Dear referees prof. Mauro Zigliotto and Marco Tursini,

I write this document to answer to the issues highlighted by prof. Mauro Zigliotto. Each answer has a number referred to the question he expressed in the file attached to his review. I report his original file as well at the end of this letter for better clarity.

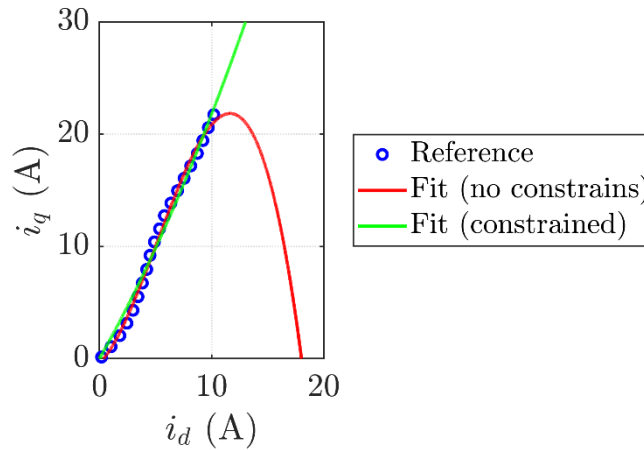
15. It is true that, generally speaking, polynomial functions may not be able to properly extend the measured data out of the measurement. As an example, monotonic reference characteristics may be approximated with a fitting function presenting undesired maximum or minimum. An example is given in the following Figure, reporting the reference MTPA (blue dots) of a SyR motor and its interpolation with a third order polynomial (red line).

15. p.90 "[...] Moreover, the analytical functions permit to extend the magnetic characteristic out of the measurement range." This is not true, in general. Polynomial functions tends to give wrong values out of the domain in which they have been obtained.

As can be seen, even if the MTPA trajectory is always growing when increasing i_d , the fitting function presents a local maximum and starts decreasing for $i_d > 11$ A. Anyway, this problem can be solved by imposing the polynomial parameters to be non-negative, thus forcing the fitting function to be monotonic, at least for positive i_d . Although the root mean square error inside the measurement domain will be surely higher, the qualitative shape of the function is guaranteed. This has been done in the green line of the same Figure. In the same way, the analytical model presented in (3.37) can properly describe the flux maps even out of the identification measurement domain. This concept is now better clarified in the text of the manuscript, just after the model equations (page 90).
